**SUBJECT:** Transmittal of Westinghouse Responses to US NRC Requests for Additional Information on the AP1000 Application for Design Certification

# AP1000 DESIGN CERTIFICATION REVIEW

## Response to Request For Additional Information

Revised Figure 3.8.3-7  
IRWST Temperature Transient

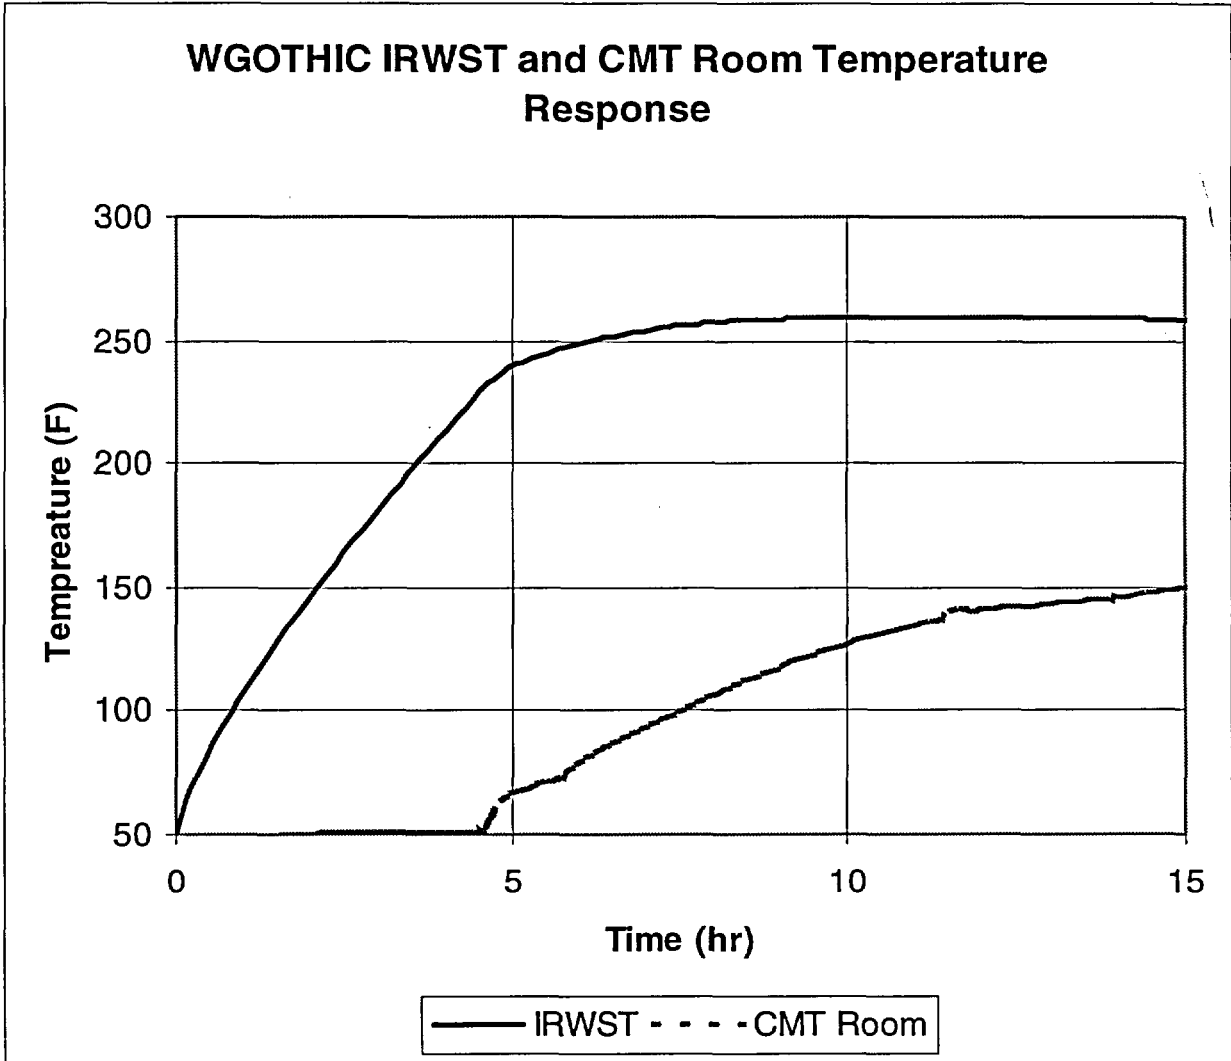
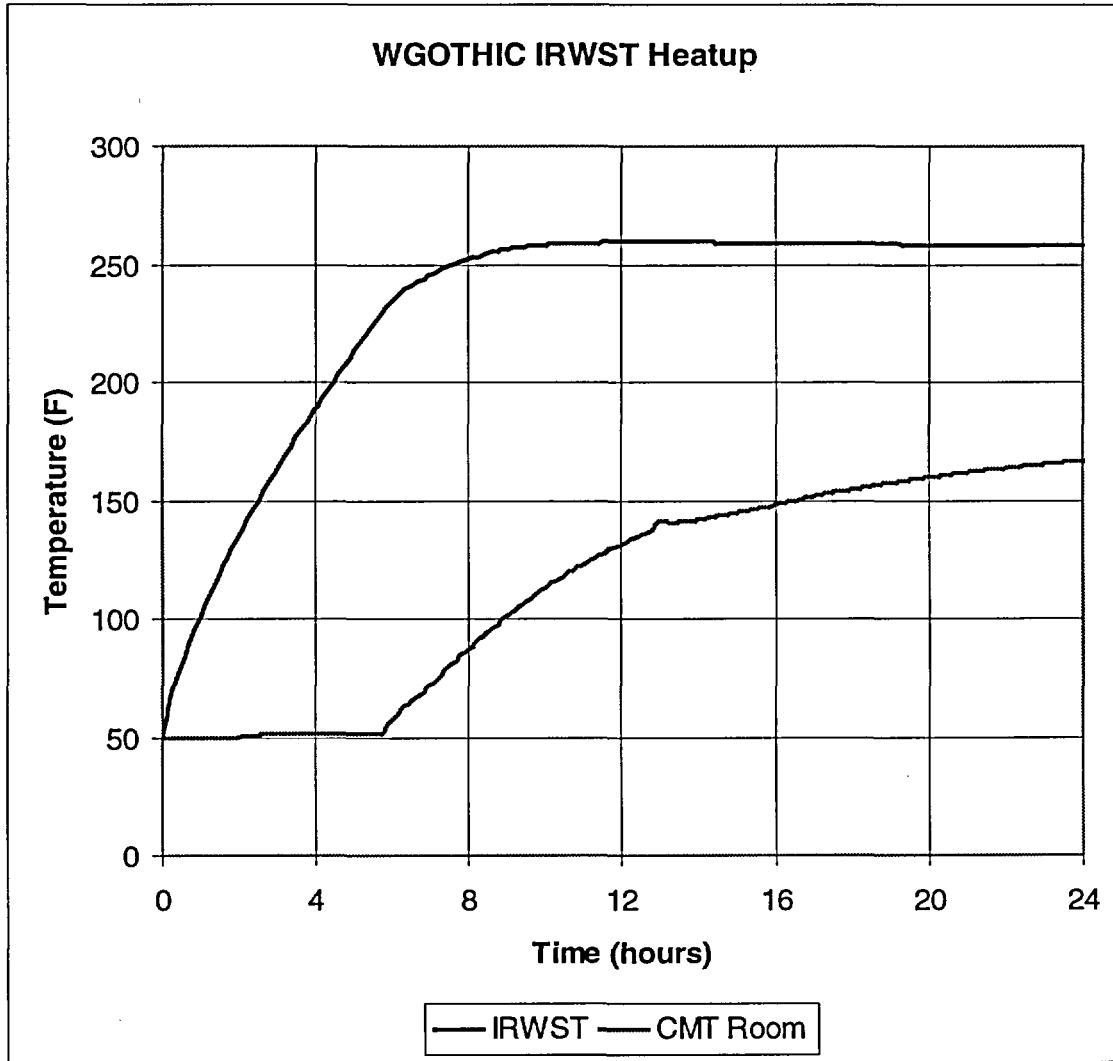
- A. The transient temperature was revised from 240°F reached in 5.5 hours (AP600) to 250°F reached in 3.5 hours (AP1000). Provide a discussion to explain the change and how this change was considered in the analysis and design of the AP1000 modules?
- B. The extreme transient starting temperature used for the structural design was revised from 50°F (AP600) to 70°F (AP1000). This would seem to be less extreme than the 50°F case in the AP600 design. Provide the basis for this change and explain how this change was considered in the analysis and design of the AP1000 modules?

This RAI response was discussed at the NRC Structural Meetings held at the Westinghouse offices on April 2-5, 2003. At the meeting, it was requested that additional clarification and justification of the analysis assumptions be provided in a revised RAI response.

The thermal transient associated with operation of the passive core cooling system that was provided in the Revision 0 response has been revised. The previous transient was calculated with a simplified bounding model that resulted in overly conservative thermal gradients across the IRWST wall. The calculation has been revised using the Westinghouse WGOTHIC containment model that is used to perform the Chapter 6 design basis containment analysis.

The IRWST temperature transient is shown in the attached revised DCD Figure 3.8.3-7. The temperature transient has been modified based on a more conservative assumption regarding the cooldown time of the reactor coolant system.

The IRWST begins steaming approximately 4 hours after the event is initiated, and reaches a maximum temperature of 260°F in approximately 11 hours. The containment atmosphere heats up once the IRWST steams. This transient will be used to determine the thermal loads on the IRWST walls. Also shown in Figure 3.8.3-7 is the CMT room atmosphere temperature which serves as the boundary condition on the opposite side of the wall. There are no changes in the analysis or design criteria for the structural modules for thermal effects. The critical loading for the concrete filled steel plate modules above the containment internal structure basemat is the thermal gradient across the wall. Close to the containment internal structure basemat the critical loading is the maximum temperature difference between the steel plate and the basemat concrete. The design of the structural modules for the AP1000 IRWST transient will be available for review during the NRC audit of critical sections.

The attached figure replaces DCD Figure 3.8.3-7

Figure 230.022-1  
Free-body Diagram for Containment Internal Structures Overturning Evaluation

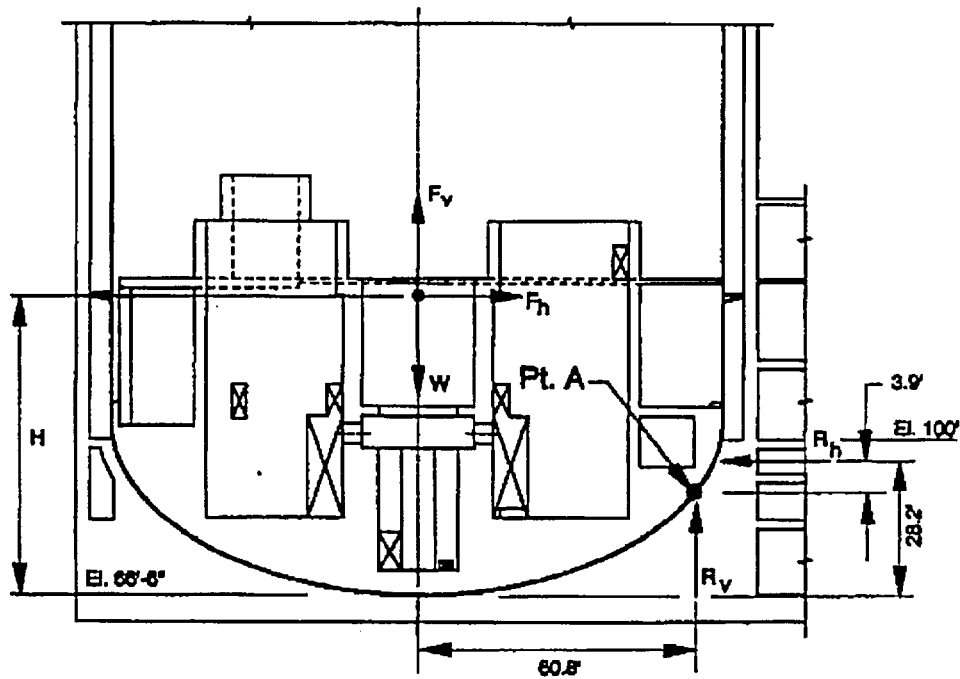
The basemat is represented by a three-dimensional finite element model with the computer program ANSYS (Design Control Document (DCD) Reference 21). The model considers the interaction of the basemat with the overlying structures and with the soil. Provisions are made in the model for two possible uplifts. One is the uplift of the containment internal structures from the lower basemat. The other is the uplift of the basemat from the soil. The staff notes that uplift and slapping back of the containment internal structures on the basemat would affect both the seismic design loads and in-structure response spectra for all SSCs associated with the containment internal structure, and would also affect the seismic response of the steel containment shell. Please clarify how these effects have been addressed in the seismic analyses used for design of the containment and containment internal structures.

The bottom head of the containment vessel rests on the nuclear island basemat. The containment internal structures basemat rest within the bottom head. There are no shear studs or anchors designed to transfer loads tangential to the vessel surface. The interface is designed to transfer load in compression and friction. The configuration is identical to the AP600 and the stability evaluation shown in Figure 230.022-1 follows the AP600 methodology described in the AP600 response to RAI 230.47.

The provisions in the nuclear island basemat model are included for use in the equivalent static analyses to develop design loads for basemat design. The uplift capability assures that the reaction between the two basemats is correctly transferred as compression loads only. The stability evaluation shows a factor of safety against overturning of about 2.5. Since the deadweight has not been overcome no "liftoff or slapping" is expected to occur. However, allowing for a small separation of the containment internal structures from the basemat, there would be no significant effect to the seismic design loads or the in-structure response spectra. A small separation (slapping) might cause small localized changes in seismic response loads similar to those for the lift off observed between the nuclear island basemat and the rock addressed in the response to RAI 230.021. Any change in high frequency response due to "slapping back" would not propagate through the building structures to affect the seismic response. This is because of energy loss, damping, and filtering effects due to gaps and cracking. Therefore, it is not necessary to modify the analysis methods from those that were accepted by the NRC for the AP600 plant.
